Re: Pacific Family Dental parking lot expansion

We have reviewed the site plan for the enclosure for this site. The enclosure is described as a 20' x 10' area.

Exhibit F

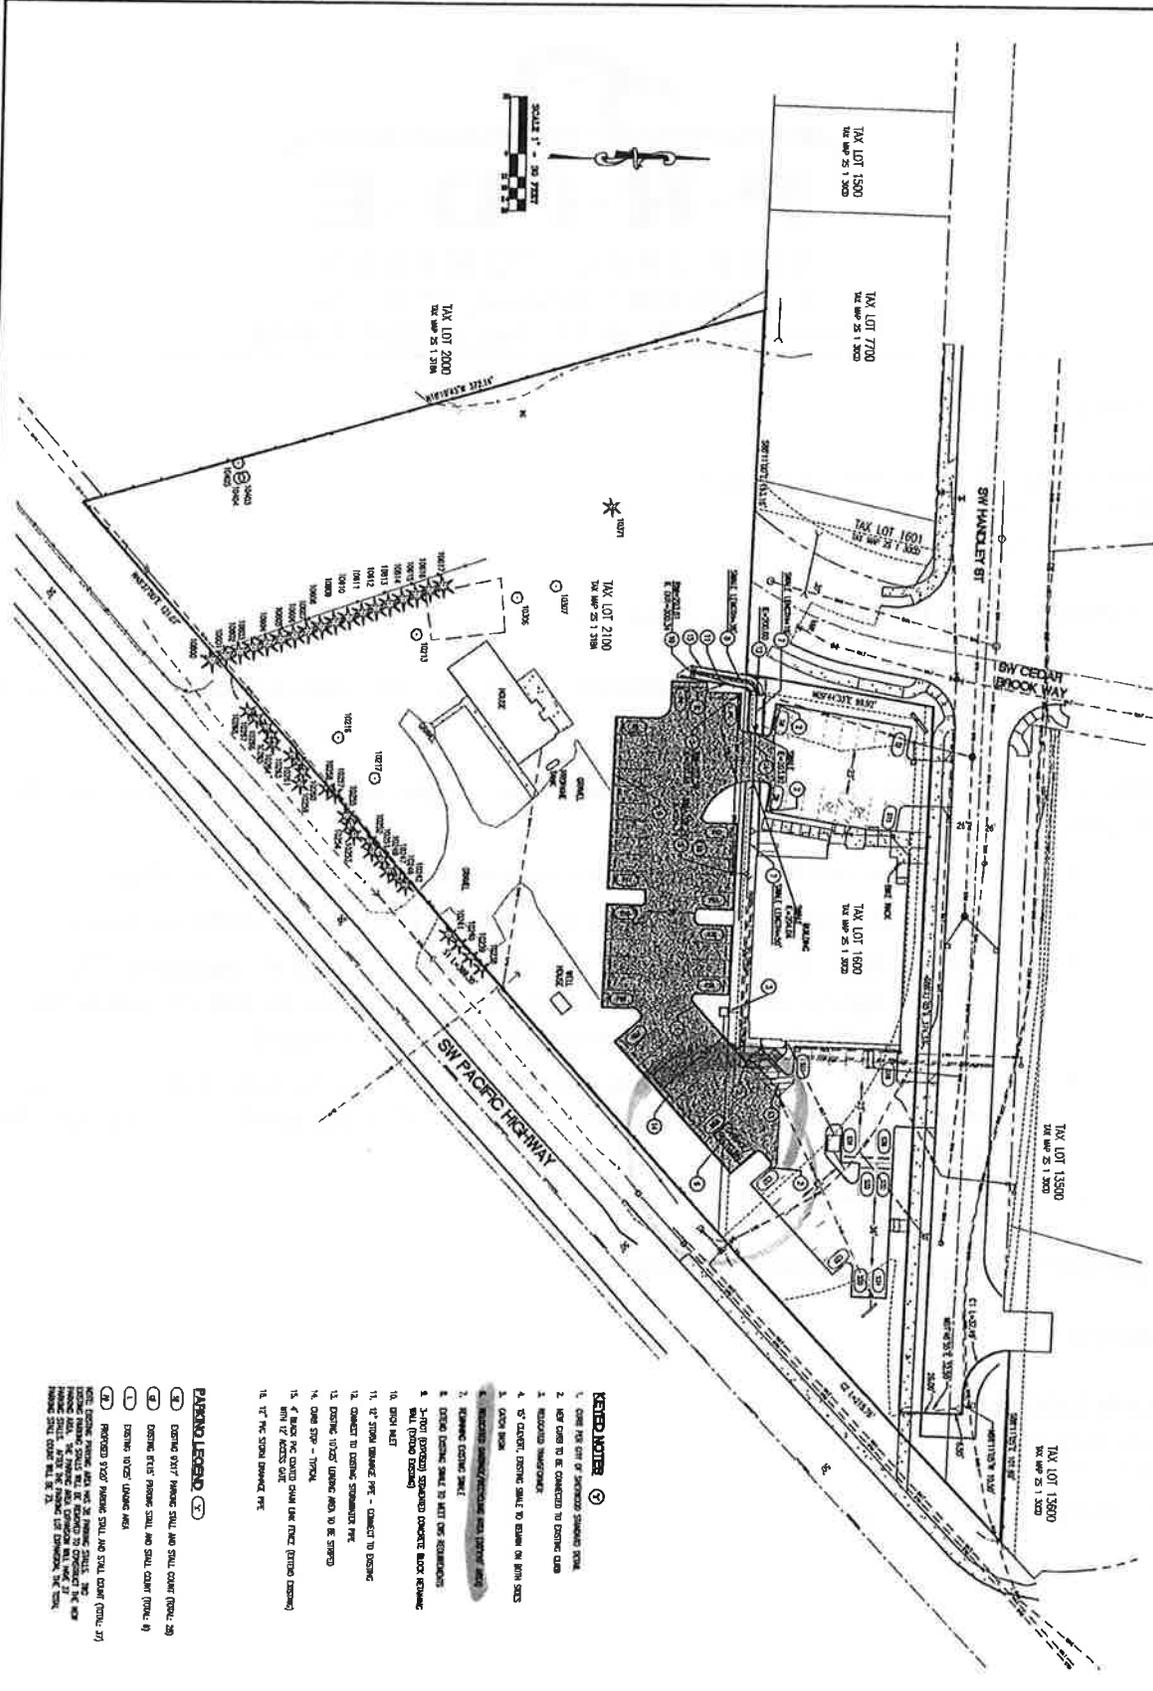
There are some additional requirements that need to be met that cannot be determined from the site plan:

- The enclosure needs to have inside measurements of 20' wide and 10' deep.
- There should be no center post at the access point in the center of the enclosure.
- The gates will need to allow for the full 20' needed to access the enclosure. They should be hinged in front of the enclosure walls to allow for the full 20' width. This will also allow for the 120 degree opening angle that is required.
- The gates need cane bolts and holes put in place for the gates to be locked in the open and closed position. The holes for the gates to be held open need to be at the full 120 degree opening angle.
- No roof on the enclosure
